**UNITED STATES
NUCLEAR REGULATORY COMMISSION
ADVISORY COMMITTEE ON REACTOR SAFEGUARDS
WASHINGTON, DC 20555 - 0001**

SUBJECT: WORKING COPY OF THE MINUTES OF THE MEETING OF THE
ADVISORY COMMITTEE ON REACTOR SAFEGUARDS
SUBCOMMITTEE ON RADIATION PROTECTION AND NUCLEAR
MATERIALS, HELD ON JUNE 20, 2011

ADVISORY COMMITTEE ON REACTOR SAFEGUARDS
Radiation Protection and Nuclear Materials Subcommittee Meeting Minutes
June 20, 2011
Rockville, MD

Criticality Safety Systems Cornerstone Key Attributes

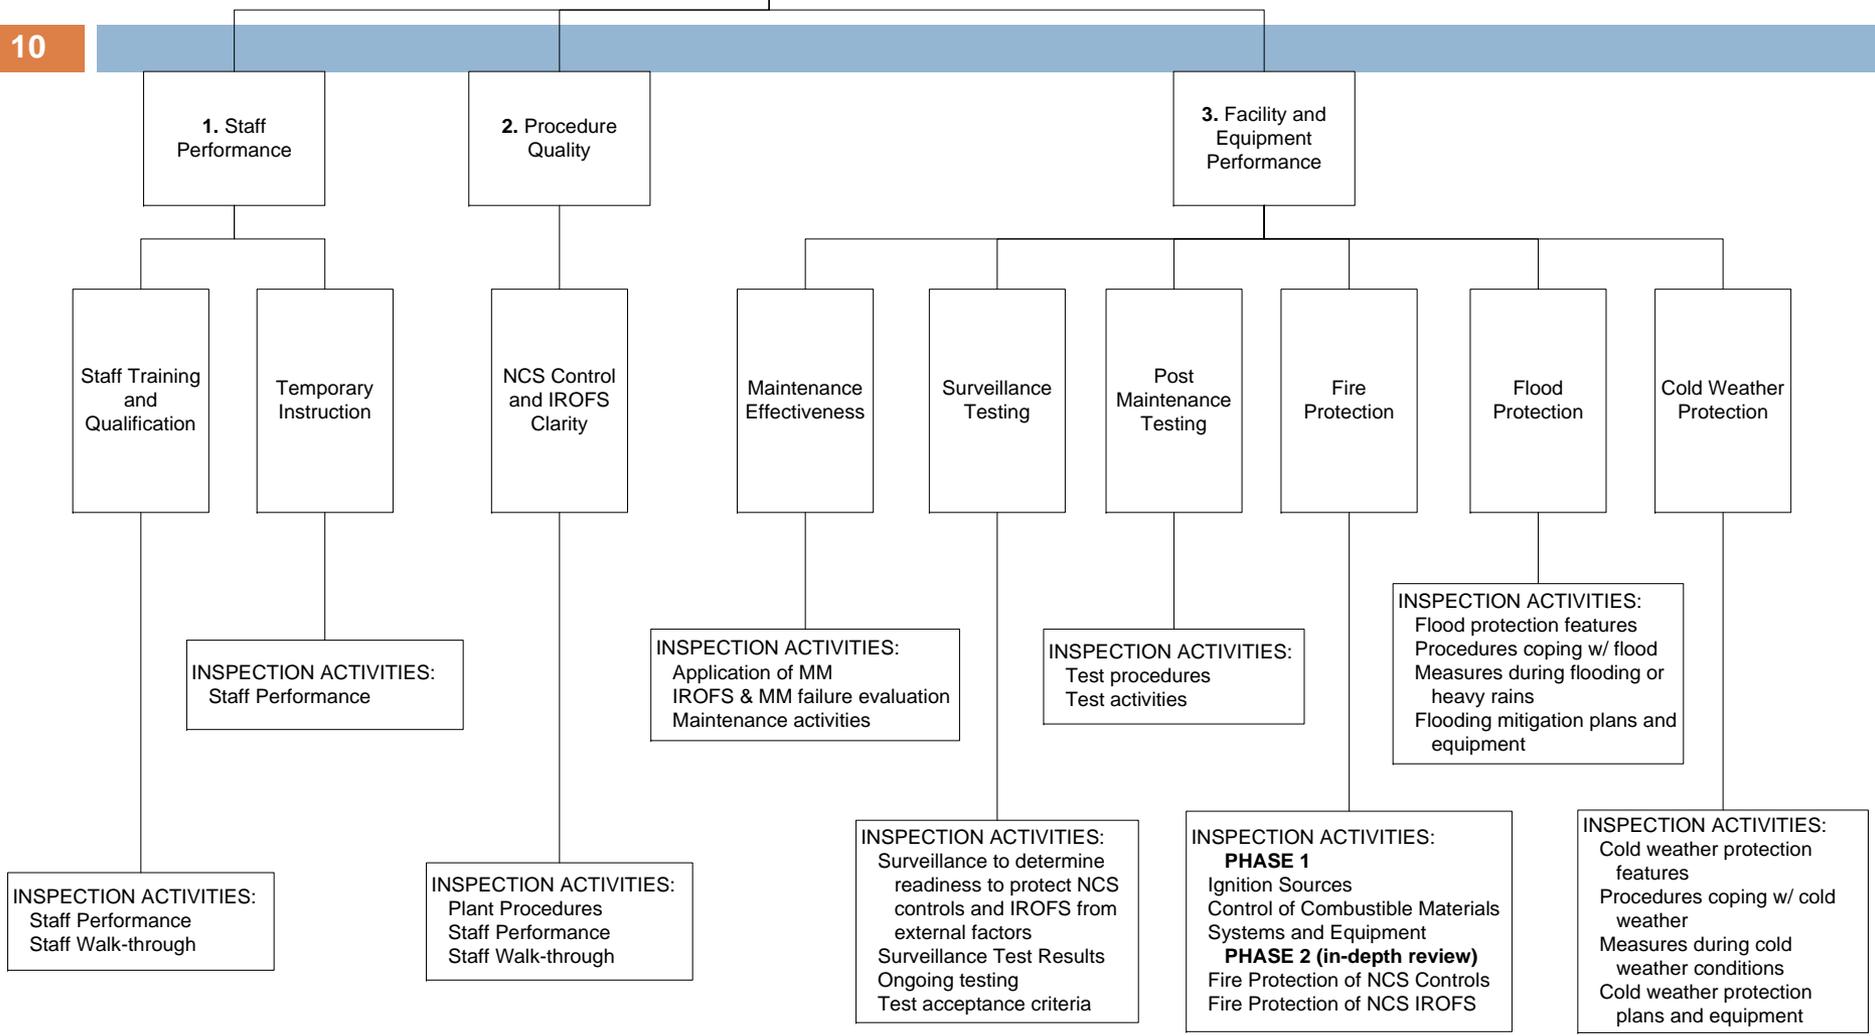
6 CONSULTANT FLACK: -- a question on
7 this? Again, getting back to the question on fire
8 protection, I see it listed on the facility and
9 equipment performance, but say I raise that up to a
10 cornerstone. Wouldn't these other things apply as
11 well, like staff performance, procedure quality and
12 so on and so on? I mean, how does that all get
13 folded up into the fire protection program from
14 below? It looks like it's just focusing on things
15 related to facility, equipment and performance.
16 That's what I'm --

12 MR. COLLINS: Anybody who showed up at a
13 public meeting, but for the most part it's licensees
14 at public meetings who've said really think about
15 it. Is that where we ought to be considering? I
16 think the substance would change as to what we mean
17 by "fire protection." But the question was do we
18 give it the importance of making it something
19 separate when it fact it really is integrated with
20 all of the equipment cornerstones, and even
21 radiation safety cornerstones.

10

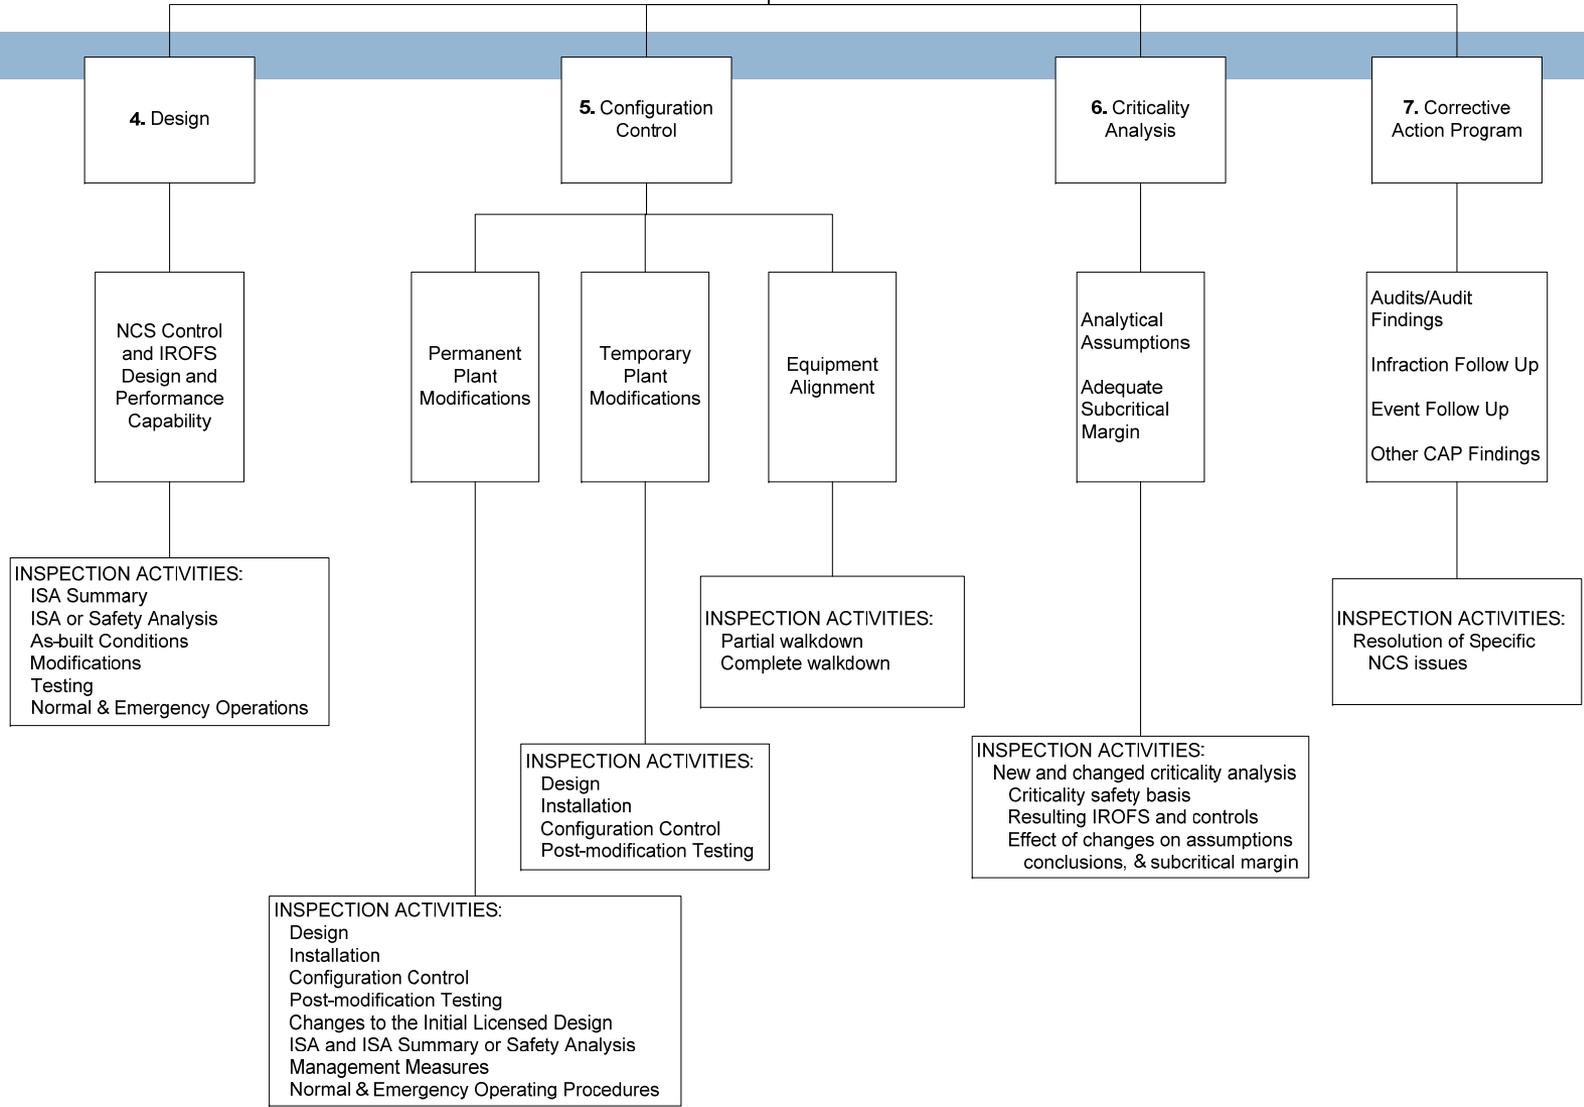
12 MEMBER ABDEL-KHALIK: Review of the
13 design happens early during the licensing of the
14 facility. And it would seem to me that for an
15 oversight process, which you ought to be focusing
16 on, is item 5, configuration control. What are the
17 temporary modifications or what are the permanent
18 modifications, rather than the design per se? So,
19 can you explain to me why this item is sort of
20 explicitly included in an oversight process?

18 MEMBER ABDEL-KHALIK: So, in the context
19 of this process one may find himself reviewing a
20 design change that had not been evaluated in the
21 first place, that where the unrevised original
22 design may not have been evaluated in the first
23 place. So, how would you do that?

23 MEMBER ABDEL-KHALIK: Well, I guess, you
24 know, to me I think your presentation has too much
25 detail and not enough detail. It would seem to me

7 MR. COLLINS: It's more intended to be
8 design change; yes, sir.

6 MR. COLLINS: But back to your first
7 question: I'm not sure how you can look at a design
8 change well without looking at the original design,
9 as I think about it. So, I would anticipate; can't
10 say for sure, because, you know, these would -- how
11 this is going to be done will be reviewed or
12 determined when we revise the inspection procedures.
13 But I would expect design changes will have to at
14 least look at part of the original design.
